DEPARTMENT OF WATER RESOURCES

Re: Requests for Variance to Use Power Consumptive Coefficient (PCC) and Flowmeter Spacing
PRELIMINARY DENIAL to use PCC: 2 of the 11 wells submitted
STATUS UPDATE on Variance Request for Flowmeter Spacing: 4 of the 11 wells submitted

REQUEST FOR VARIANCE OF IDWR APPROVED FLOW METER REQUIREMENT

#5

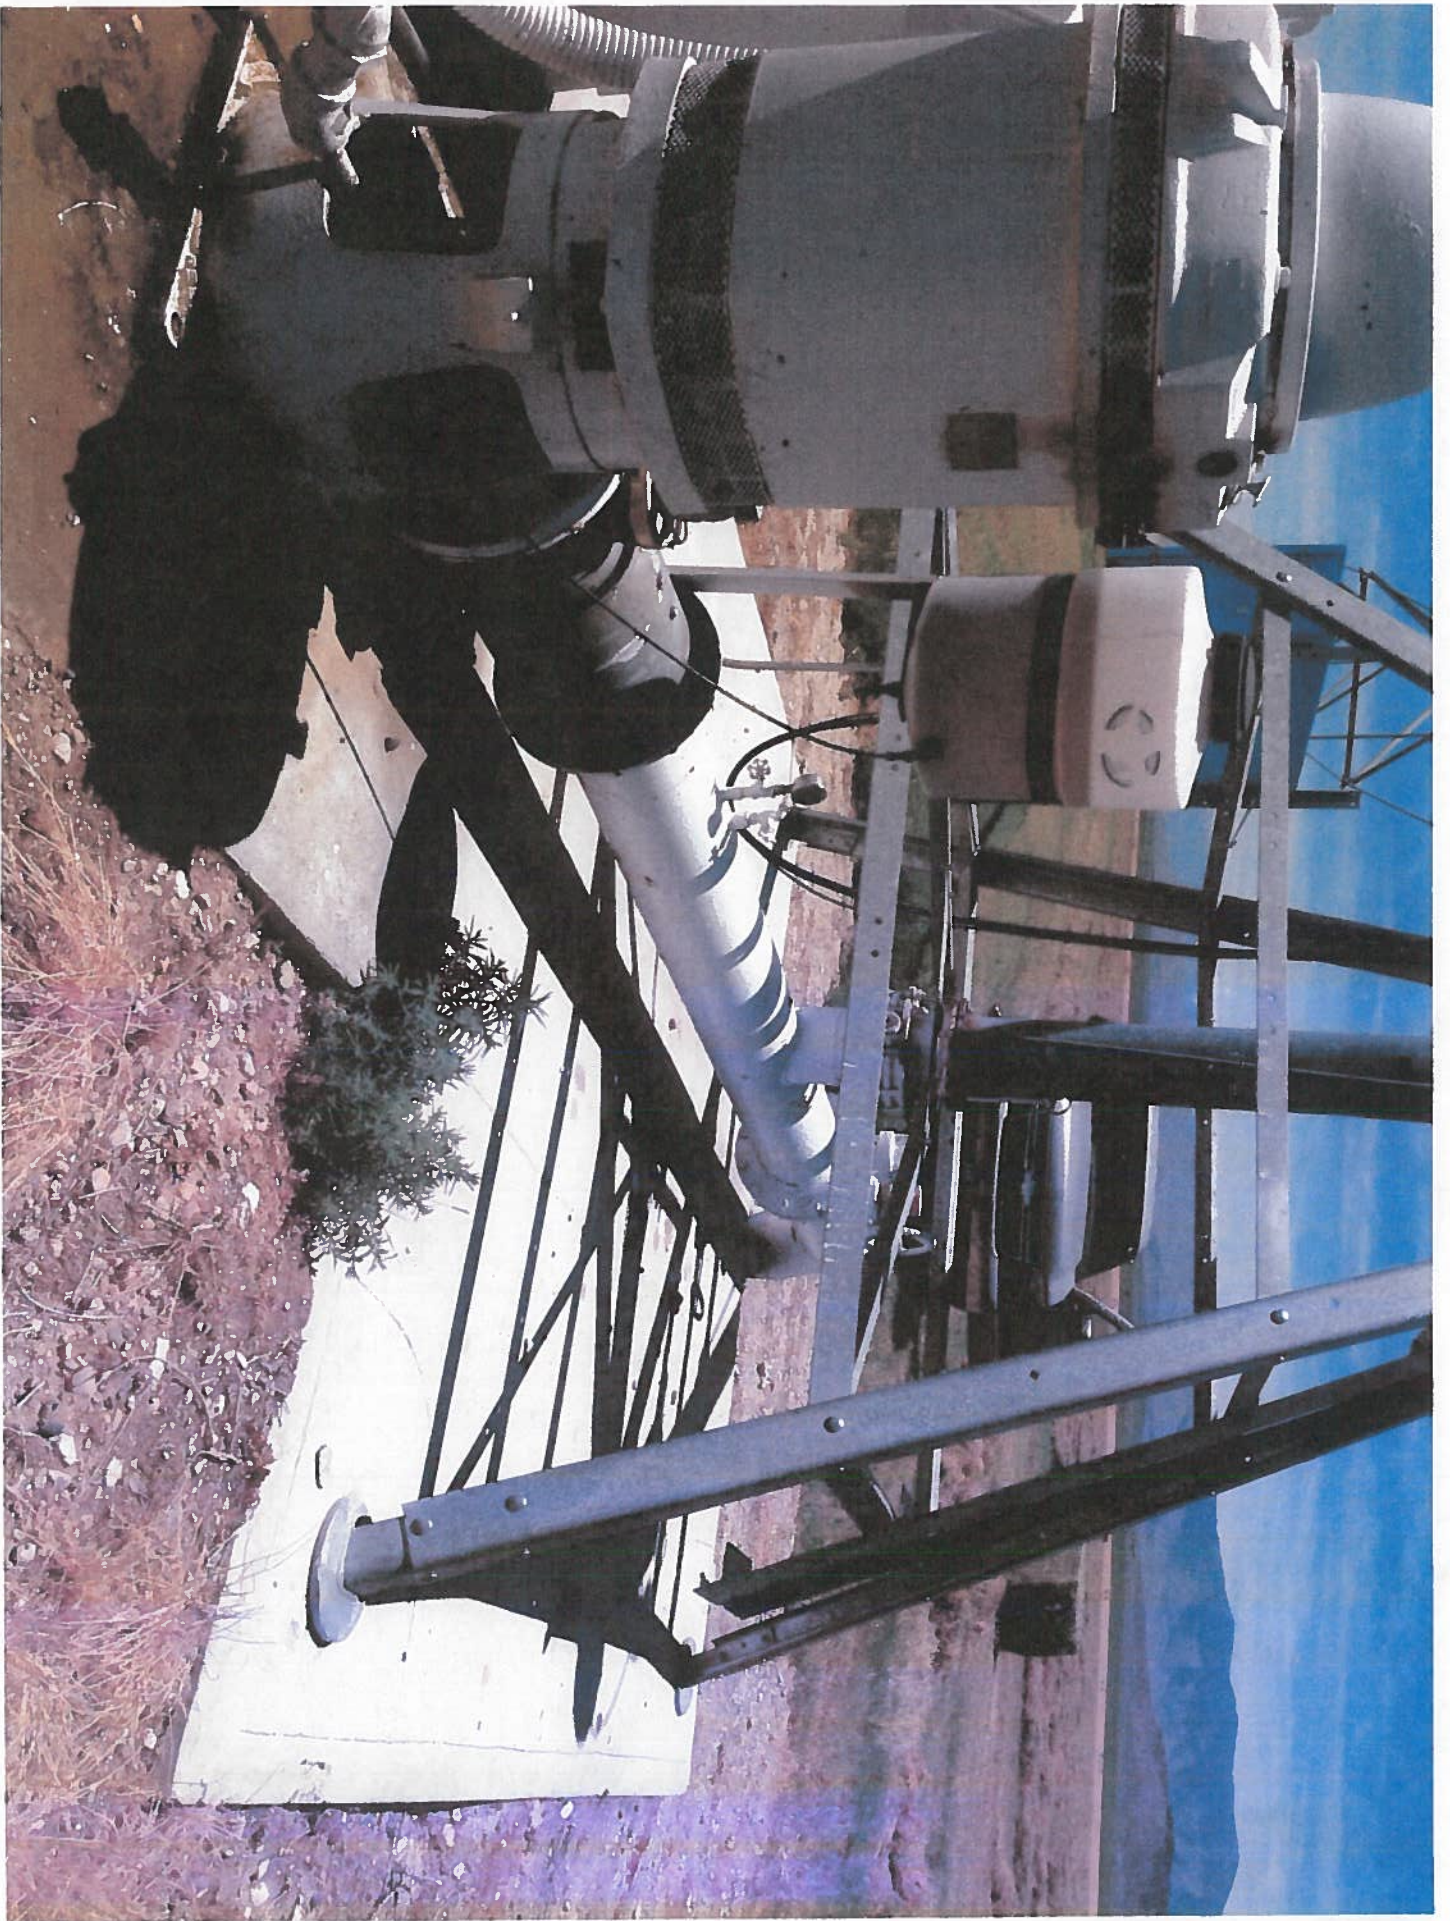
- Please indicate what proportion of time the end gun is used and if there is an end gun booster.
- Please indicate whether or not the wells #5 and # 7 are interconnected. Please describe the piping system configuration for each well and all the possible ways water can be conveyed. Specifically please provide a detailed description of how the corner on Well #5 is watered.

Well Name	IDWR WMIS Number	Metal Tag Number	Variance Tracking Number	Reason for Preliminary Denial
5	300640	A0008262	2017-336	More information about proportion of time end gun is used and pipe system. How is the corner watered? Is this well interconnected with the adjacent well 7?
9	300637	A0001858	2017-338	What proportion of time is the end gun on? Is there an endgun booster?
